AMENDMENT OF SOLICITATION/MODIFICATION OF CONTRACT			1. CONTRACT ID CODE		PAGE OF PAGES 1 8			
2. AMENDMENT/MODIFICATION NO. <div style="text-align: center;">1</div>		3. EFFECTIVE DATE <div style="text-align: center;">See Block 16C</div>		4. REQUISITION/PURCHASE REQ. NO. <div style="text-align: center;">4200467822</div>		5. PROJECT NO. (If applicable) <div style="text-align: center;">98946.1</div>

NNK13467822R – Replace Air Handling Units (AHU), Space Station Processing Facility (SSPF), Bid Package #1, PCN: 98946.1

A.) ANSWERS TO BIDDERS QUESTIONS:

Sheet E-301

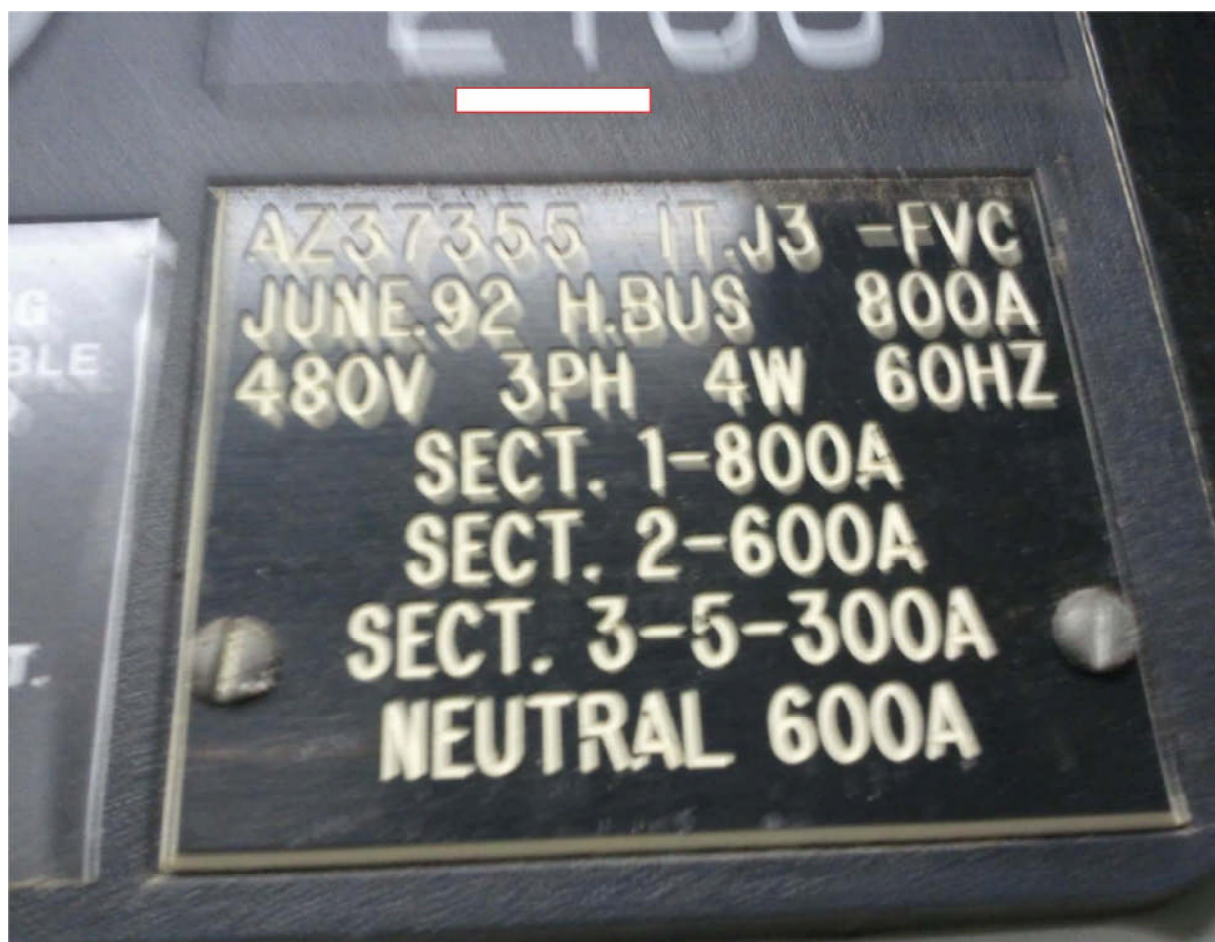
Please provide all nameplate data for MCC C3 and C5.

See attached images of MCC-C3 and MCC-C5 nameplates. Any further information required by contractor for MCC's shall be field verified by contractor.

AZ37355 IT.J3 -FVC
JUNE.92 H.BUS 800A
480V 3PH 4W 60HZ
SECT. 1-800A
SECT. 2-600A
SECT. 3-5-300A
NEUTRAL 600A
